Initial Ecological Advice for the Rezoning Proposal for Opua Development Area

Prepared for:	Jerome Wyeth on behalf of Far North District Council	Reviewed and approved for release by:  Sarah Budd Principal Ecologist, Auckland Ecology Team Leader and Coordinator
Author:	Phoebe Andrews, with technical advice from Stephen Brown (marine)	
Report No:	7617c	
Date:	August 2025

SUBMISSION 320 FAR NORTH HOLDINGS LIMITED, OPUA

Figure 3.1 Colenzo triangle site – consented site plan (Source: Submitter Evidence: Annexure 5 Colenzo Triangle Consent)

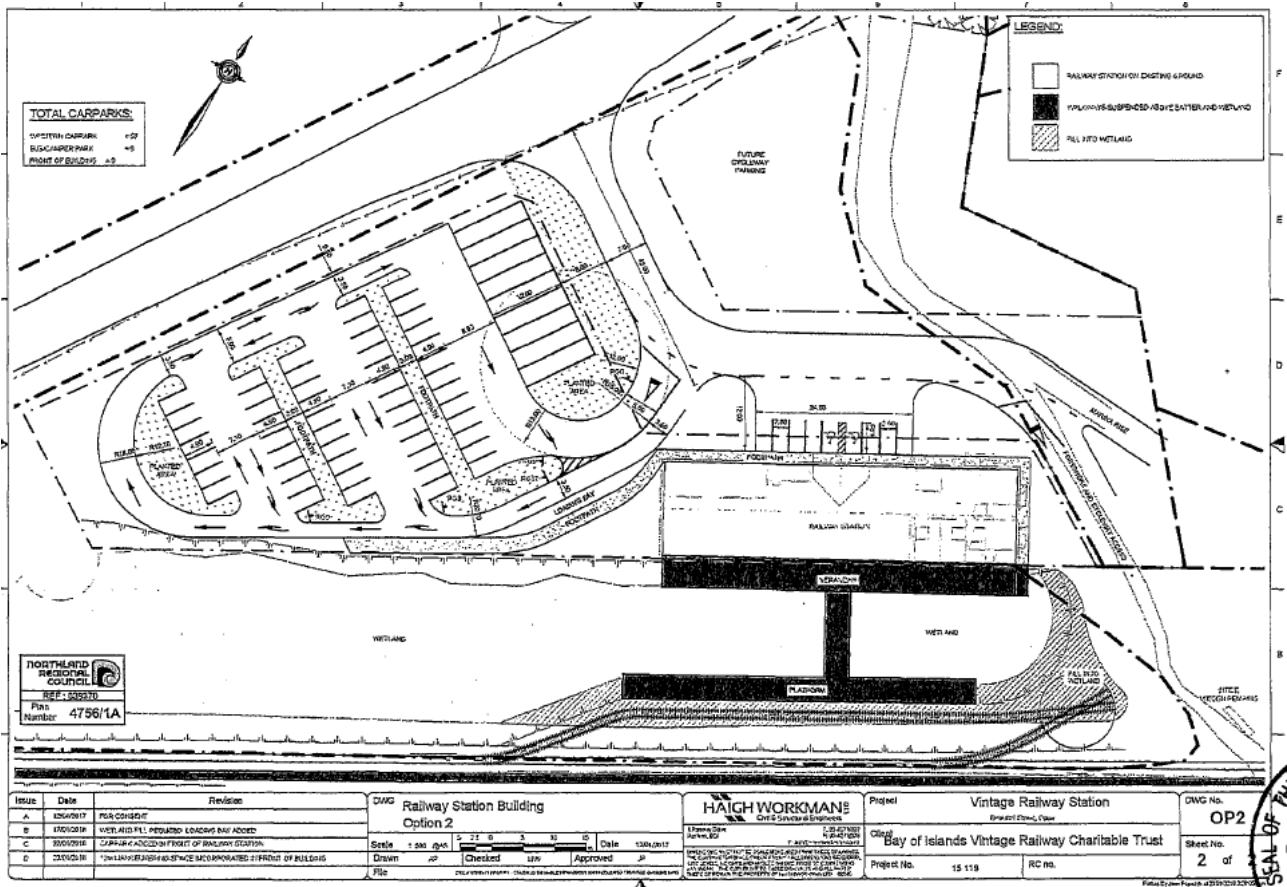
The Colenzo triangle site has an existing consent for the Bay of Islands Vintage Railway Trust to construct a railway terminus on the site. This includes a vehicle crossing onto SH10, parking, manoeuvring and associated vehicle and pedestrian accessways within the site. Refer to the consented site plan in Figure 3.1.

In my view, activities that would be enabled through Mixed Use zoning would have transport effects of a similar scale to the existing consented development for the site. I see no critical transport issues with rezoning the site and, should an alternative site activity be sought in the future, I consider that transport matters can be further considered through the PDP Transport Chapter provisions.

Figure 3: Example of Development Schedule for Character Area 2 – Opuia Gateway (source: 2.0 Provisions – Mr Sanson)

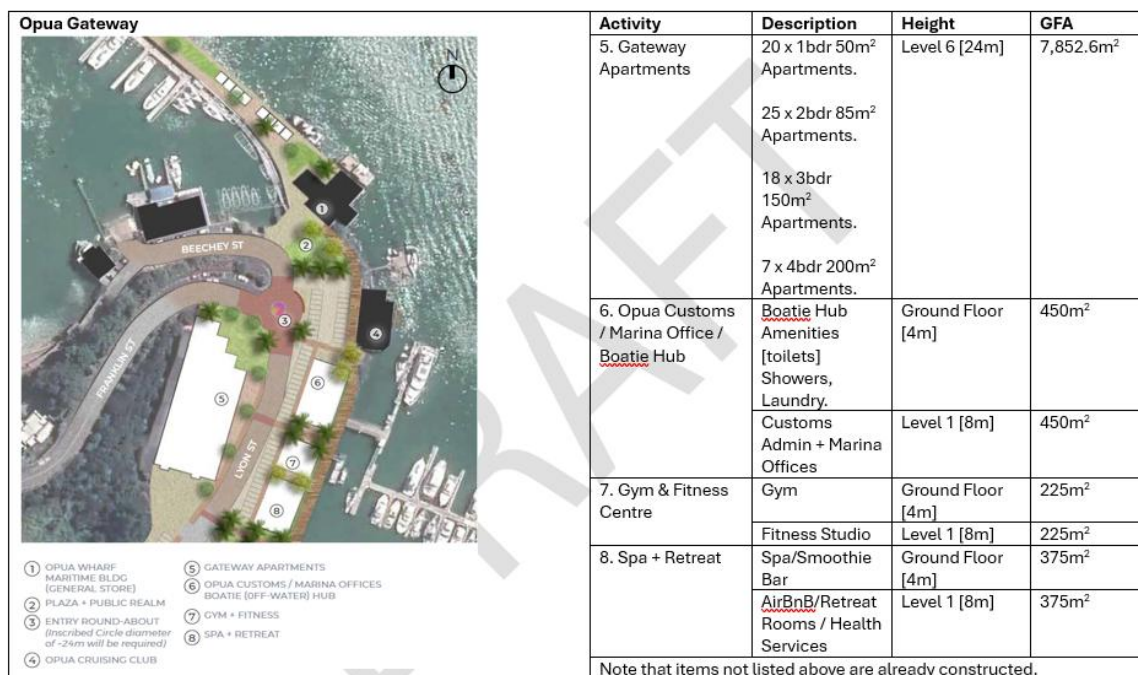
25. As outlined in *Figure 2*, there is some overlap in the Character Areas identified. For clarity and certainty it is recommended that each Character Area is clearly delineated from an implementation perspective. In addition, the Character Areas appear to be identified in the context of the existing (and proposed) buildings and land use. It would be beneficial for each Character Area to include an overview statement setting out the character attributes that currently exist within the Area and the design and development outcomes sought in the future.
